# HYUNDAI

## Technical Service Bulletin

GROUP <b>RECALL</b>	NUMBER <b>25-01-004HG</b>
DATE <b>JANUARY 2025</b>	MODEL(S) <b>G80 (DH) G90 (HI)</b>

**SUBJECT:** STARTER RELAY KIT INSTALLATION (RECALL 018G)

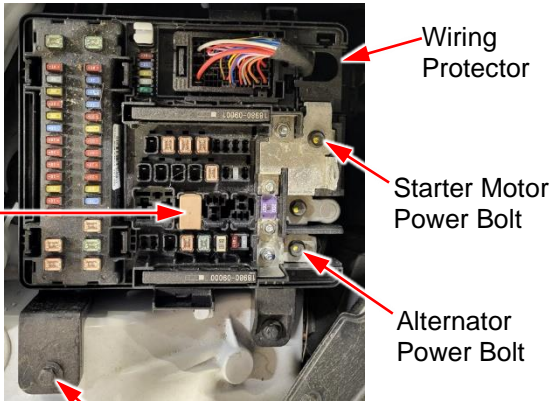
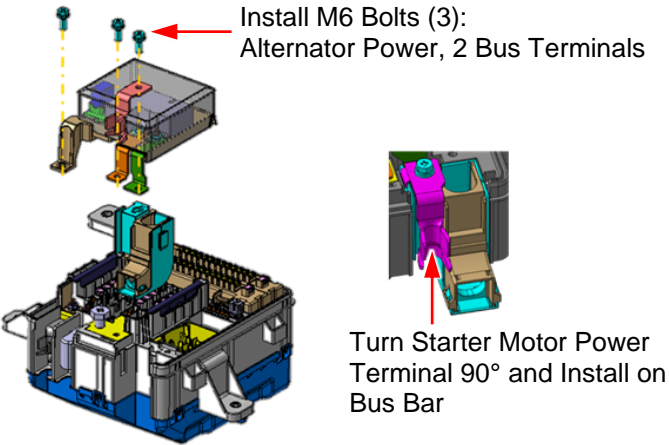
**Description:** The starter solenoid on certain 2017-2018MY G80 (DH) and 2017-2018MY G90 (HI) vehicles could be contaminated with water if operated in abnormally wet conditions, such as a flooded road. Moisture contamination within the starter solenoid could cause an electrical short over time. Follow the procedure in this TSB to install a new starter relay kit in the engine room junction box, and to replace the upper cover and upper cover label.

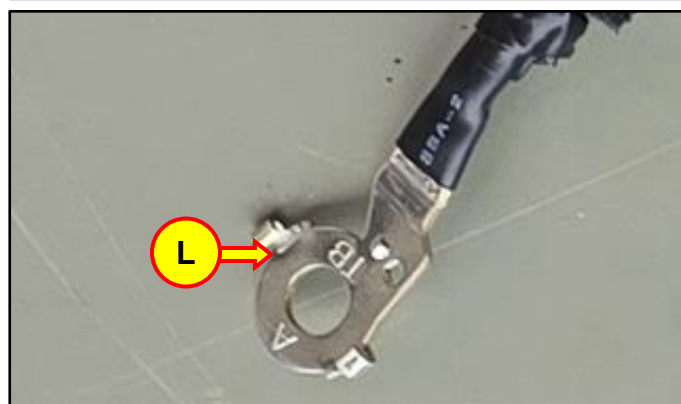
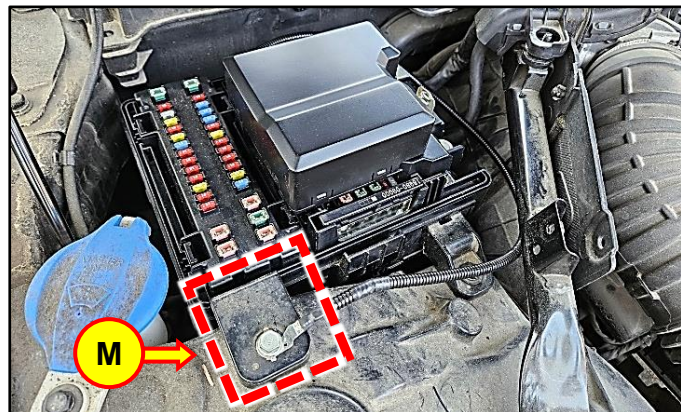
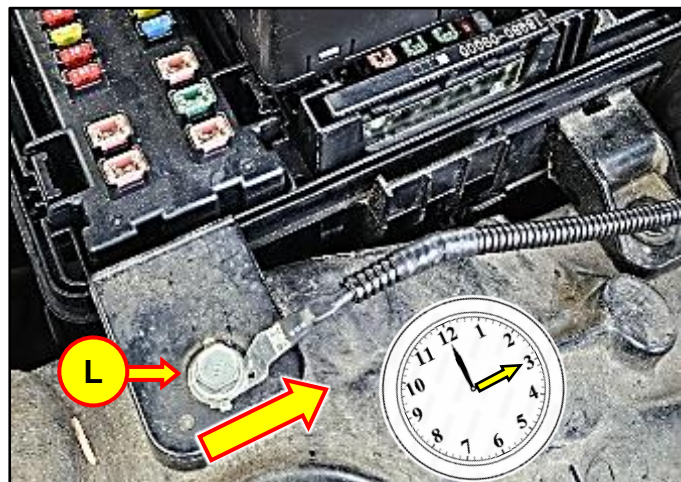
This TSB supersedes 24-01-059HG to enhance Starter Relay Kit Installation step 9 on page 13.

9. Discard the original junction box mounting bolt and use the provided ground bolt (circled right) to install the extension ground terminal (L) from the new relay kit using the existing junction box mounting location (M).

lb-ft	0.9
lb-in	10.8
N.m	1.2

Do **NOT** exceed the tightening torque above. This may damage the part.

Be sure to install the ground terminal with the protrusion facing up to prevent damaging the terminal.

The ground harness should be installed in the **3 o'clock** position, as shown.
